## ORIGINATION FORM

Proposed Revisions to a Standard Plans Index  
(Please provide all information — Incomplete forms will be returned)

Index Number: 676-010  
Sheet Number (s): 4 of 4  
Index Title: Cabinet Installation Details

**EXISTING CONTROLLER CABINET**

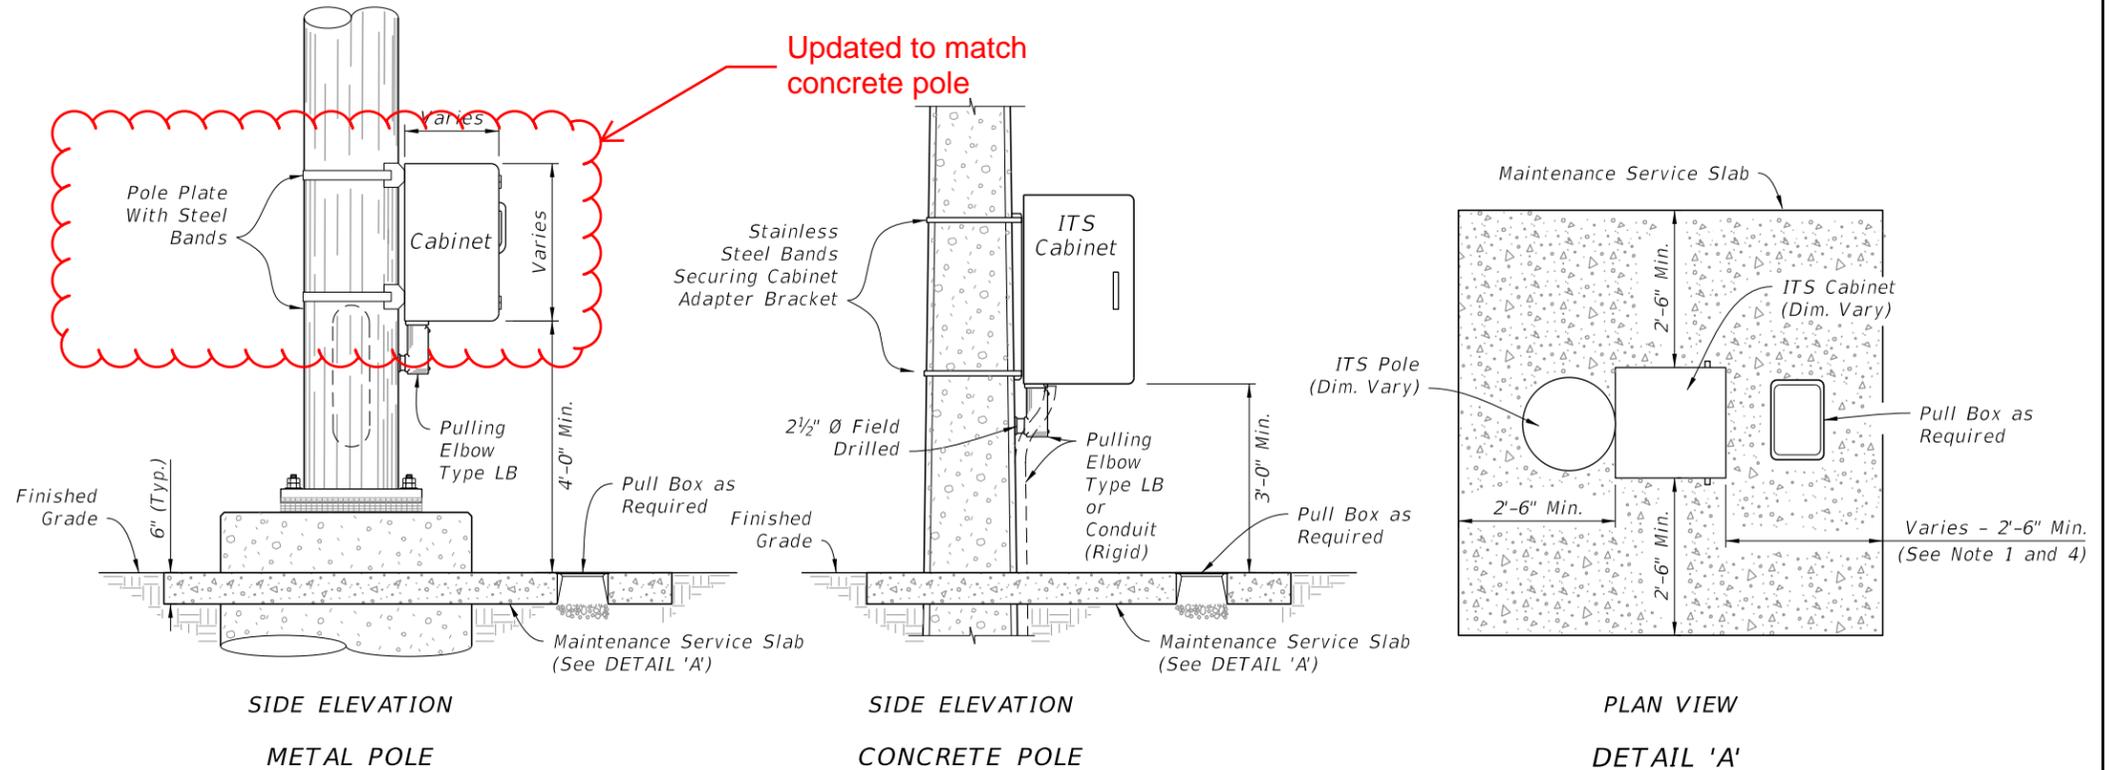
- Sheet 1: Deleted Existing Controller Cabinet elevation

**DELETED**

**POLE MOUNTED INTELLIGENT TRANSPORTATION SYSTEMS (ITS) CABINET**

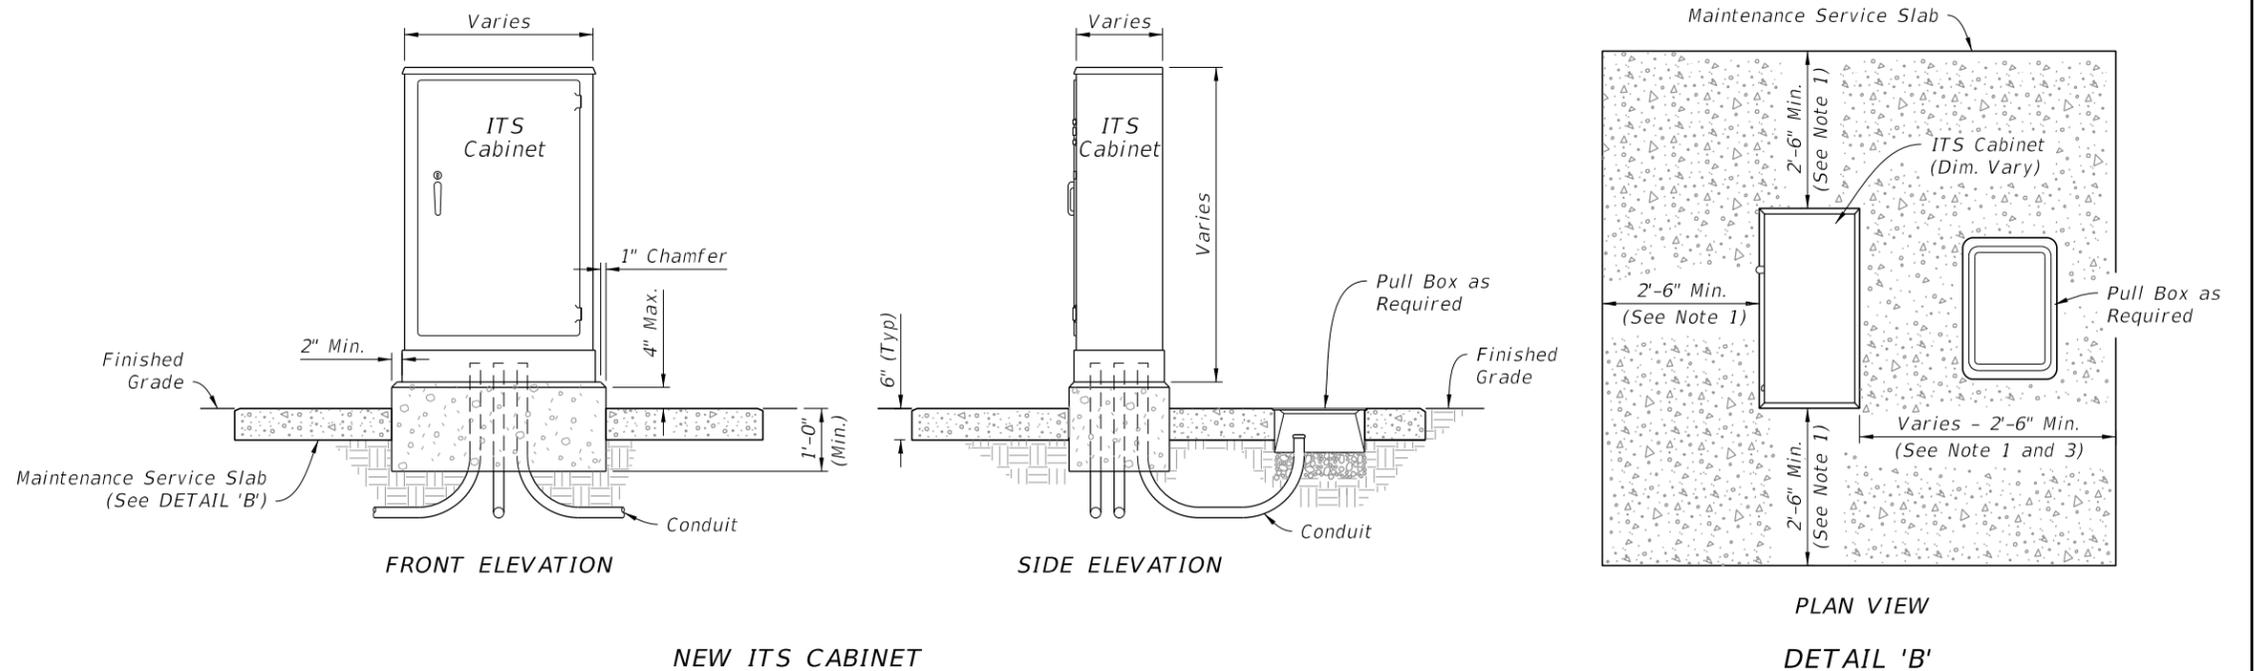
- Sheet 2: Updated Metal Pole cabinet to ITS cabinet

**GROUND MOUNTED CONTROLLER CABINET RISER**

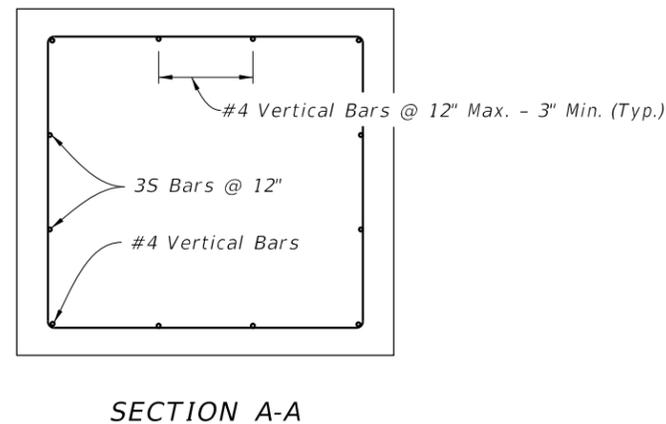
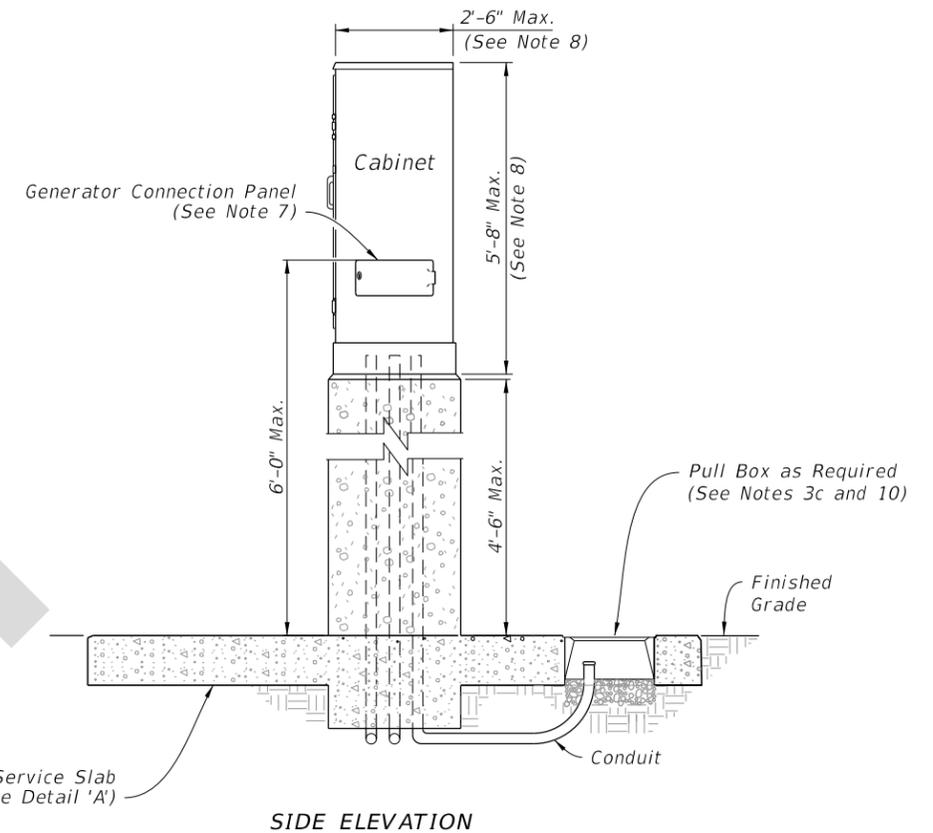
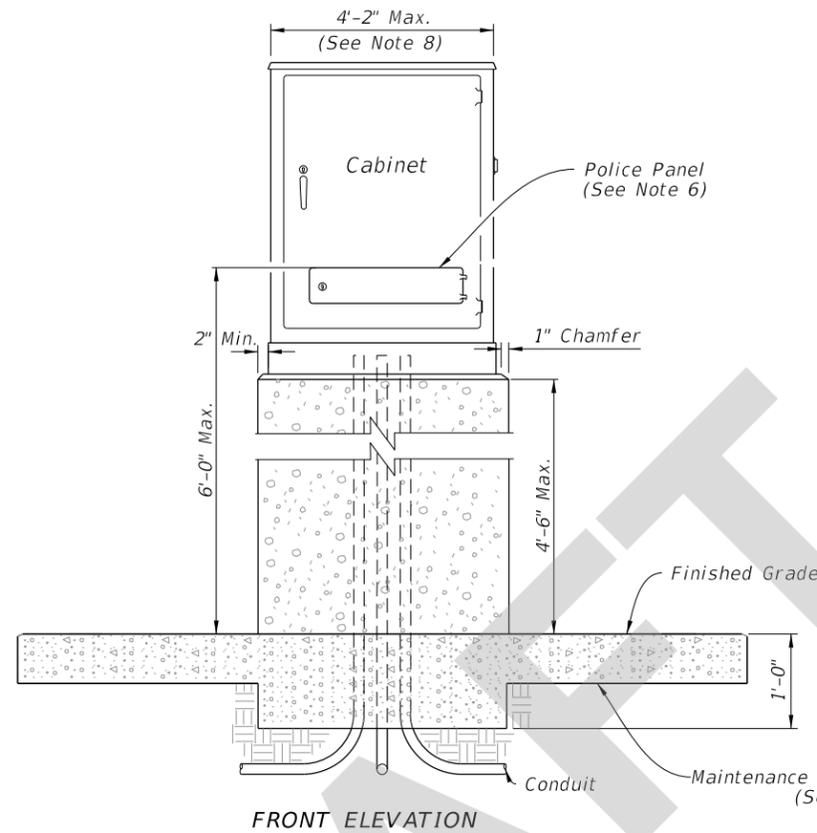
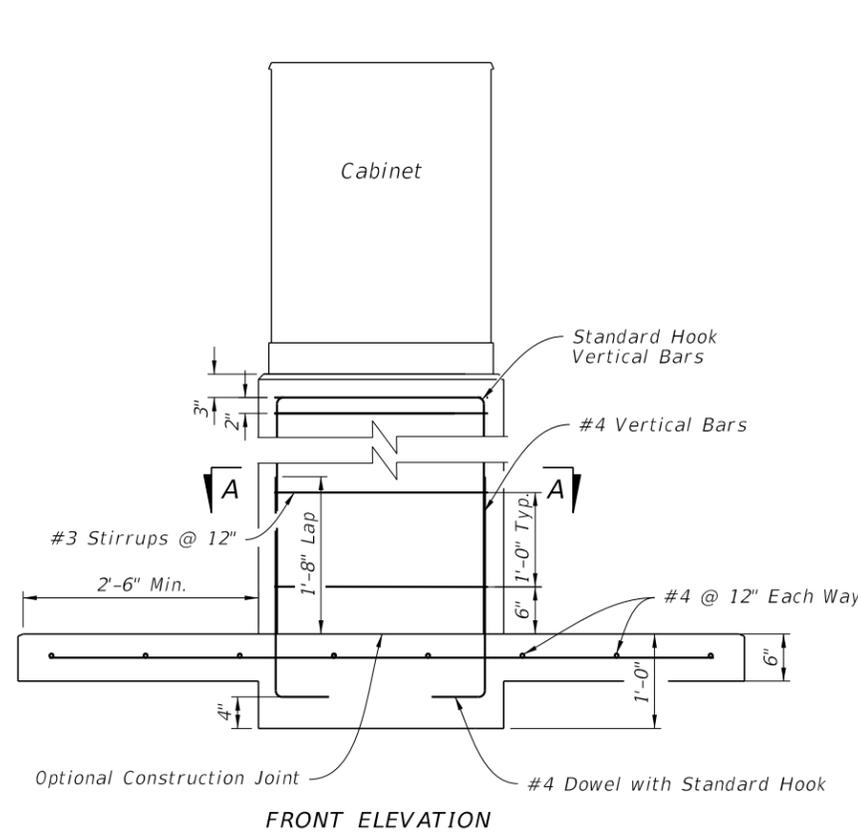
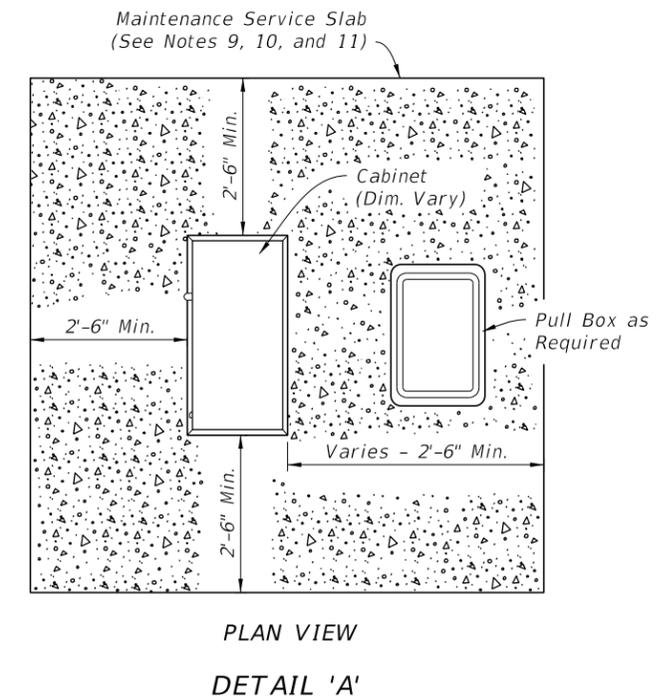
- Sheet 4: New Sheet for Ground Mounted Controller Cabinet Riser

This request came from the Districts and was coordinated with the TERL and Structures Design. Some Districts are installing these and the addition to the Standard Plans Index will allow use without a special detail in every plan set. This detail is for a concrete riser only. An associated change is being made to Specification 676 regarding this revision.

**NEW SHEET 4**
